In the matter of application for permit No. 63-32573 in the Name of M3 Eagle LLC

NACGUA's service of Ralston Hydrologic Services expert report: Hydrologic Analysis of the M3 Site: Supplement #1 Comments from Review of Geochemistry Report - Expert Report Prepared for the North Ada County Groundwater Users Association, January 2009

HYDROGEOLOGIC ANALYSIS OF THE M3 EAGLE SITE

Expert Report Prepared for the
North Ada County
Groundwater Users Association

Figure 9 2007 Measurements of Water-Level Elevation Placed on the Contour Map from Squires (2008, Figure 1)

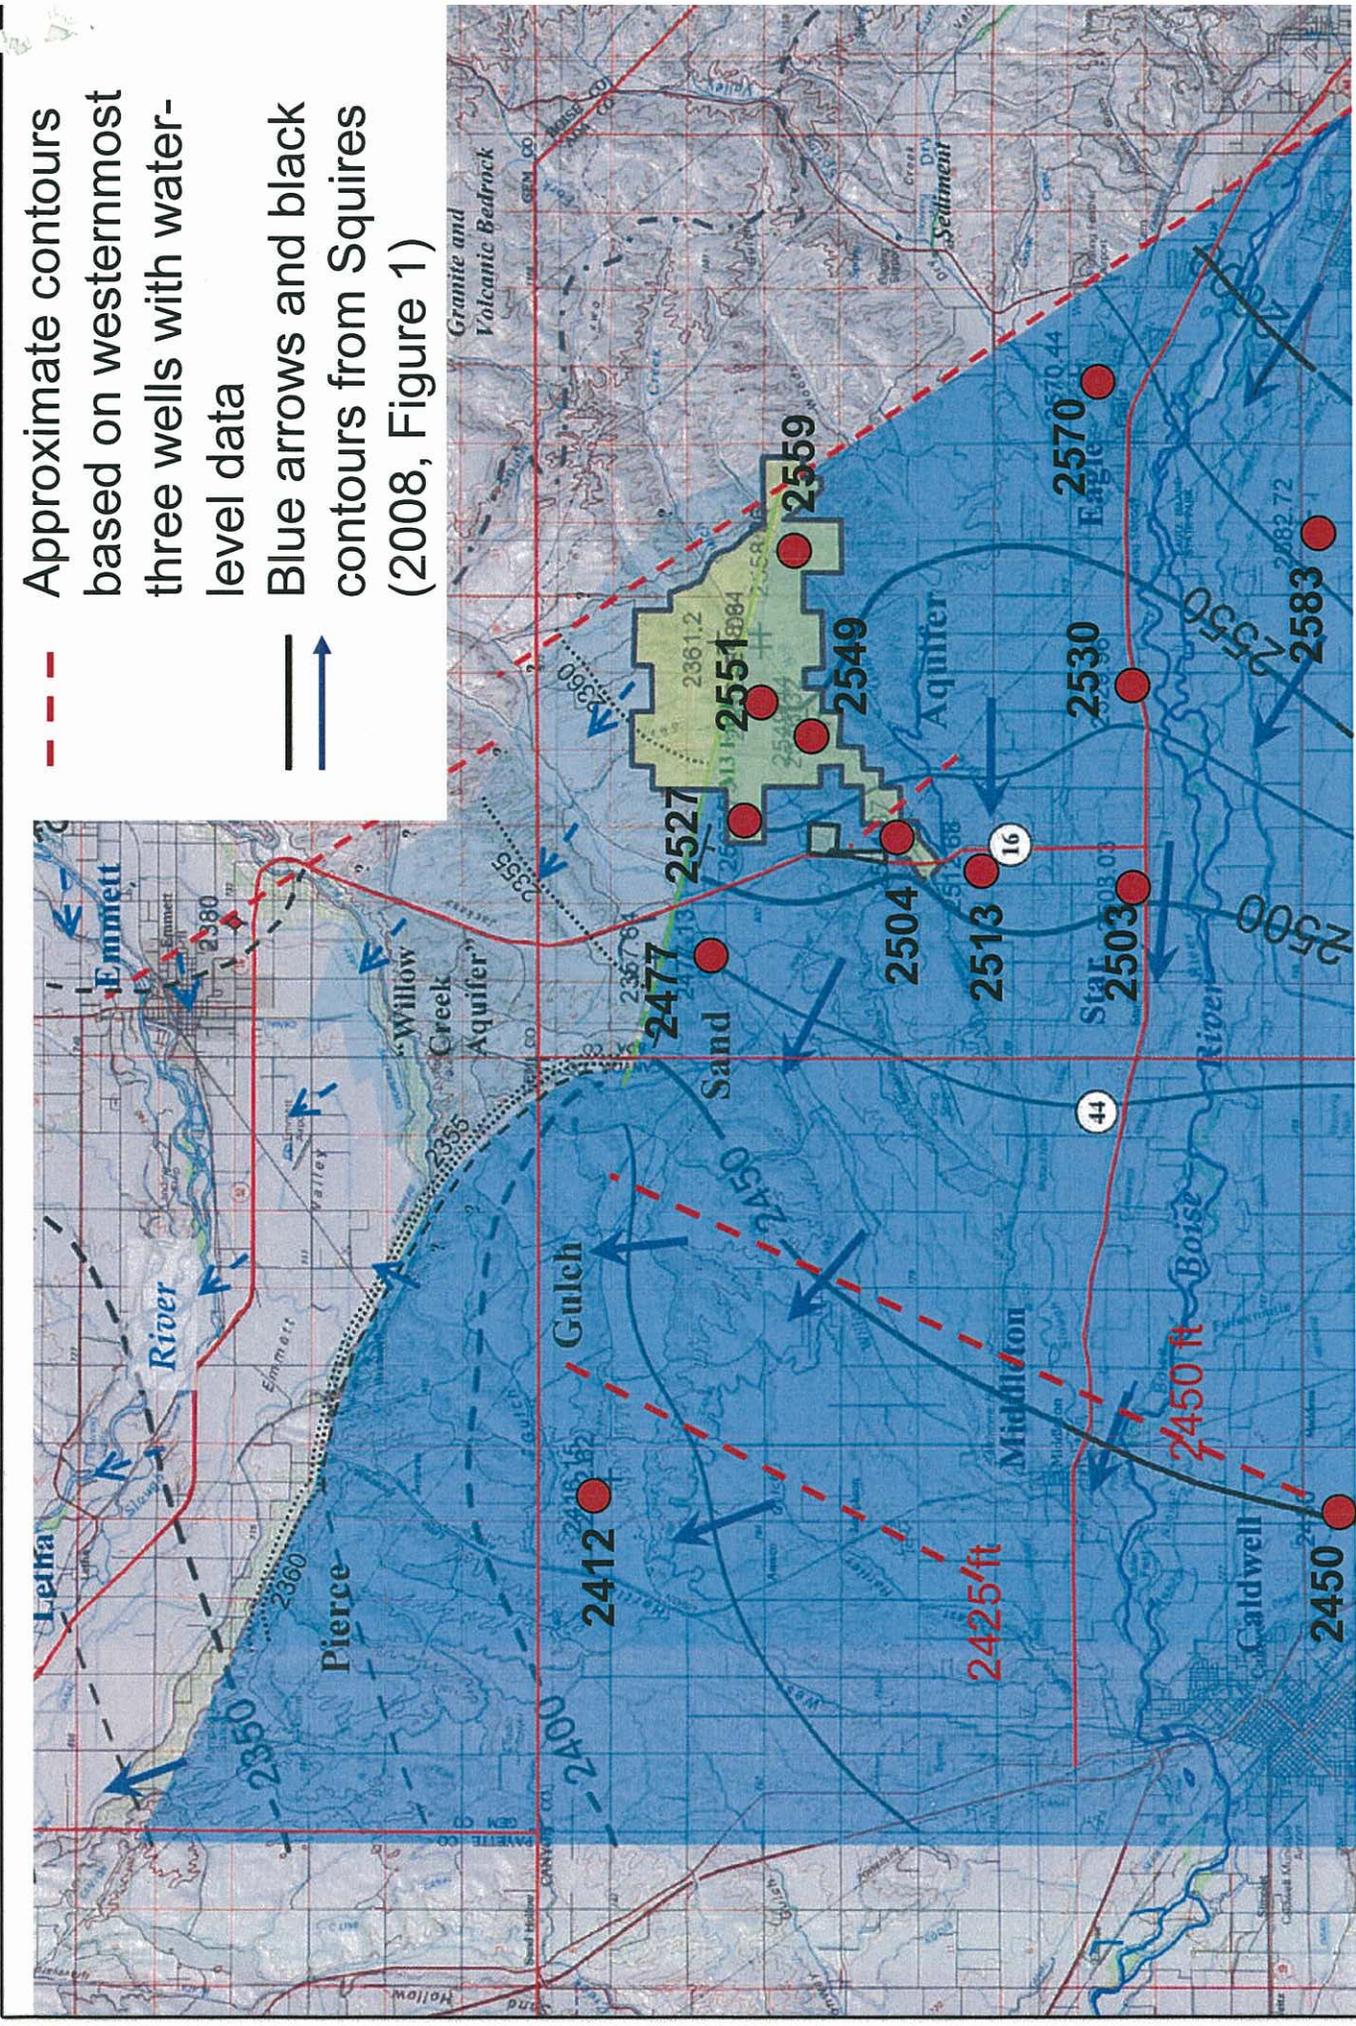
- The 2,475-foot and higher elevation water-level contours prepared by Squires (2008) are reasonably controlled by field data and show ground-water flow generally to the west-northwest.

- The JDH well (with a water-level elevation of 2,412 feet) and the Caldwell TW#19 (with a water-level elevation of 2,450 feet) are the only data points to provide control for the 2,425 and 2,450-foot contours. There are no control wells for the 2,400 foot and lower water-level contours.

- The water-level contours prepared by Squires (2008) west of the R1W/R2W range line that indicate ground-water flow to the north-northwest appear to be based on a combination of two data points (JDH well and Caldwell TW#19) and the two assumptions that underlie the M3 Eagle Analysis: 1) the Pierce Gulch Sand Aquifer is laterally continuous from the M3 Eagle area to the Payette River Valley and 2) water flows within the aquifer from the Boise River Valley to the Payette River Valley. The 2,400-foot and lower contours that show flow to the north-northwest have no control points and appear to be based on the assumptions. The 2,425 and 2,450-foot contours drawn by Squires (2008) are not direct interpretation of the field water-level data.

- The red dashed lines on Figure 9 show the 2,425 and 2,450-foot contours that I created based in a linear interpretation of the hydraulic gradient between wells with water-level data (JDH well at 2,412 feet; Caldwell TW#19 at 2,450 feet and Willowbrook Irrigation well at 2,477 feet). The red, dashed contours on Figure 9 indicate ground-water flow would be in a west-northwest direction, approximately parallel to the Payette River.

- The JDH Builders well, with a water-level elevation of 2,412 feet, is critical to the postulation that ground-water flows to the north or the north-northwest in this area. The contour map of water-level elevations would look considerably different if this well does not penetrate the Pierce Gulch Sand Aquifer.

Figure 1 Map Showing Wells Located Northwest of the M3 Eagle Site Included in the Geochemistry Analysis (Glanzman and Squires, 2009)

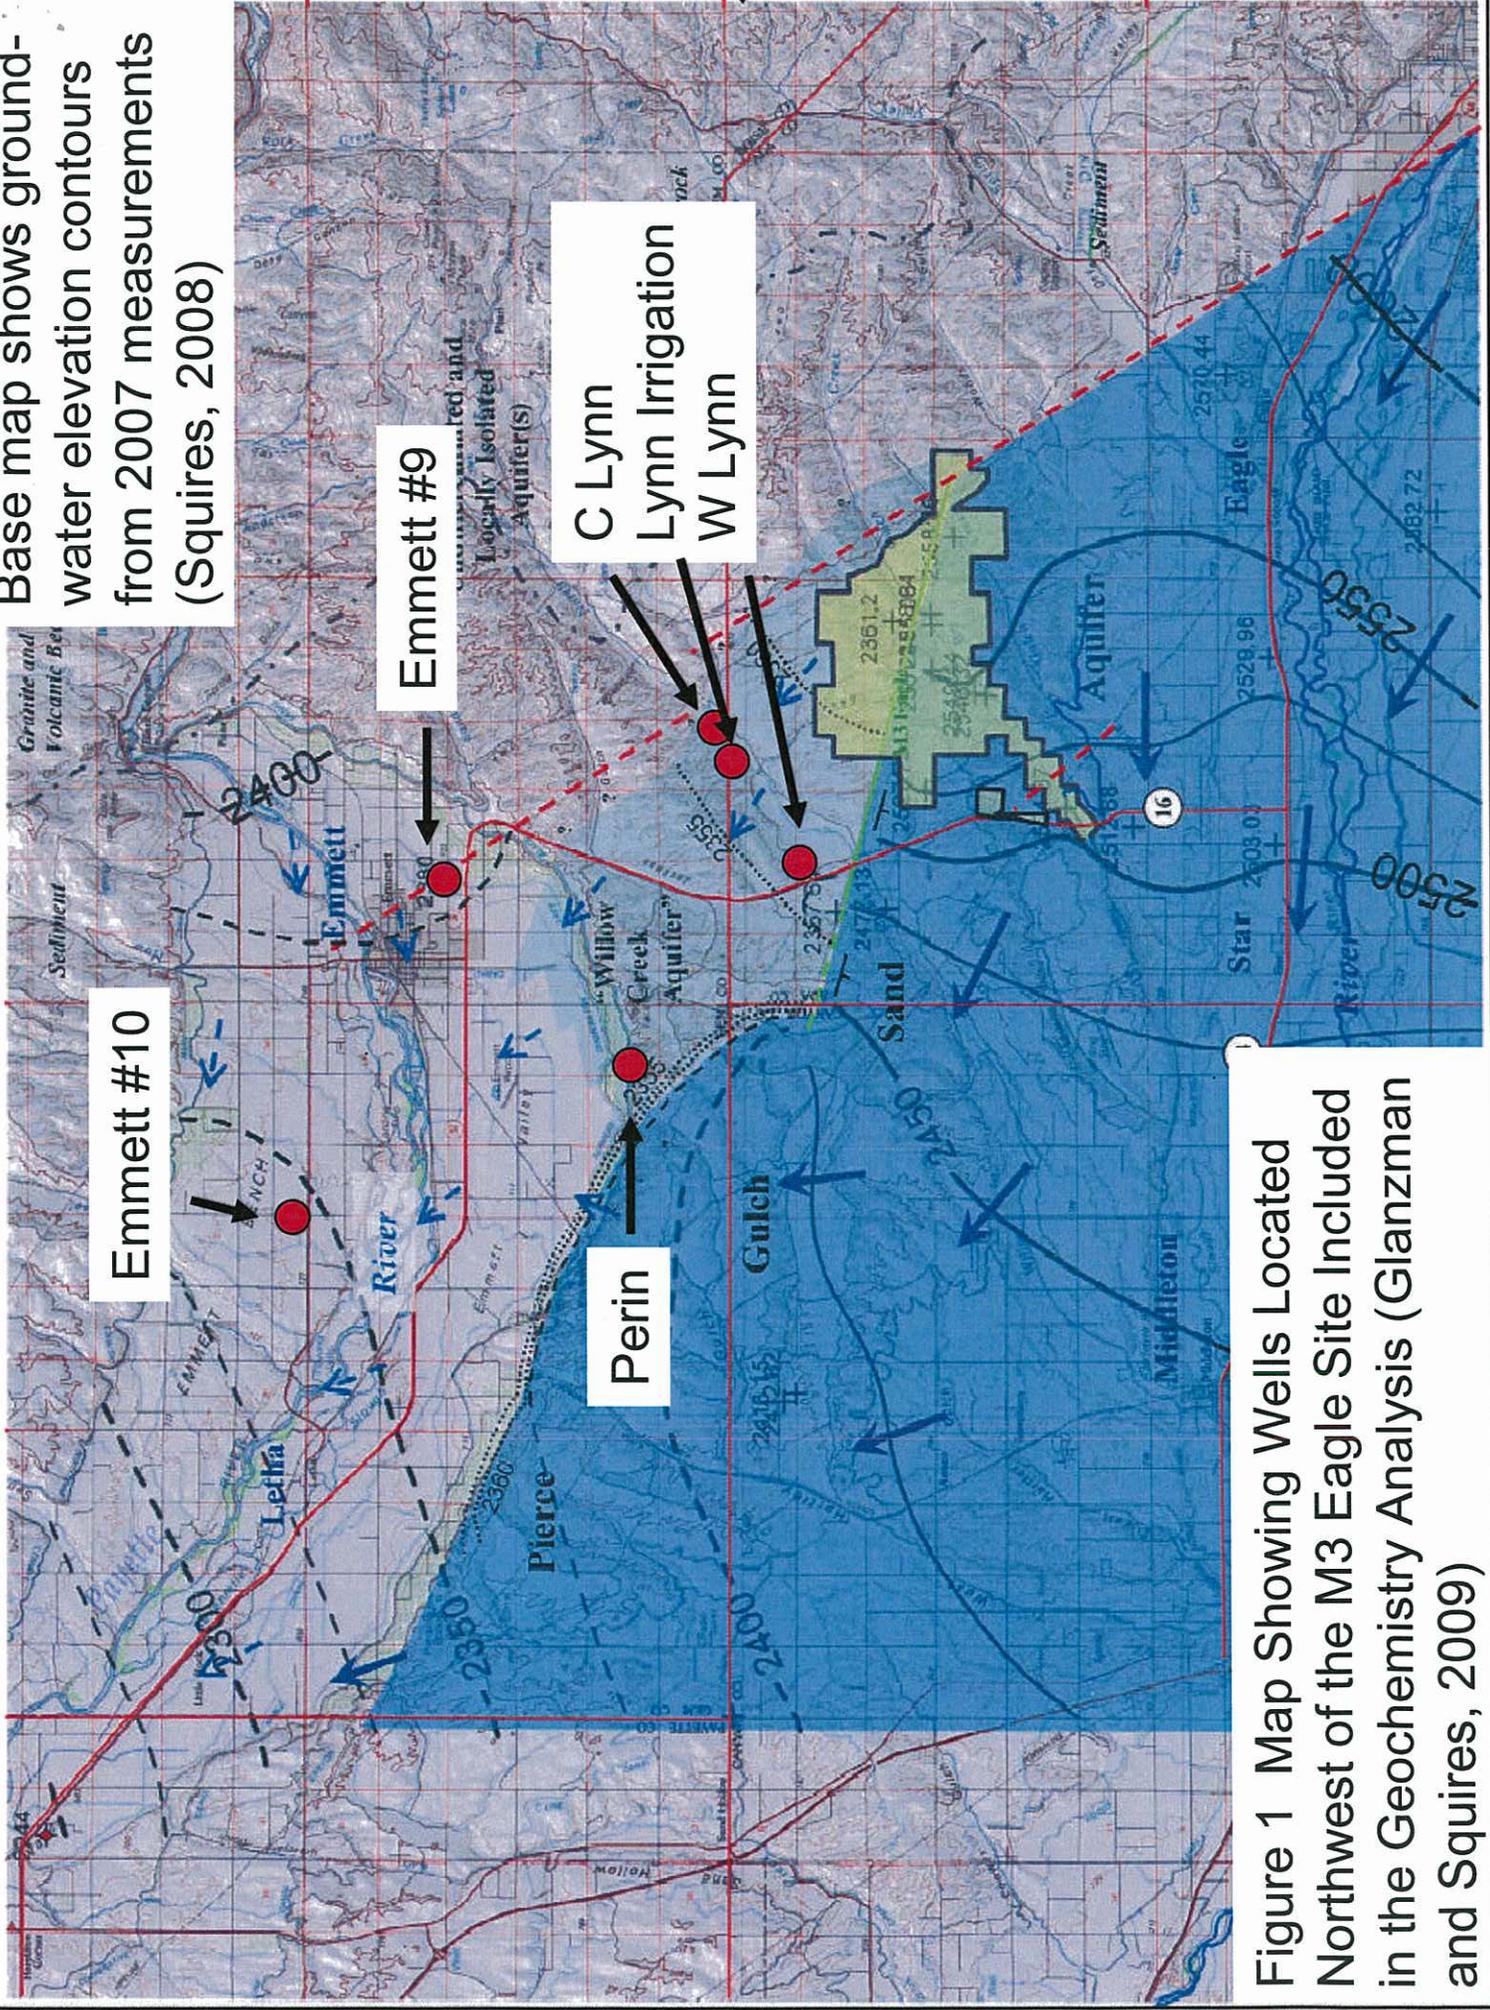
- b. Glanzman and Squires (2009) include six wells located northwest of the M3 Eagle site in their analysis (Figure 1). Four of the wells (C Lynn, Lynn Irrigation, W Lynn and Perin) appear to be located within the Willow Creek Aquifer. The remaining two wells (Emmett #9 and Emmett #10) are located on the floor of the Payette River valley. Glanzman and Squires specifically indicate that, based on water chemistry, the two Emmett wells have no hydraulic connection to the PGSA.
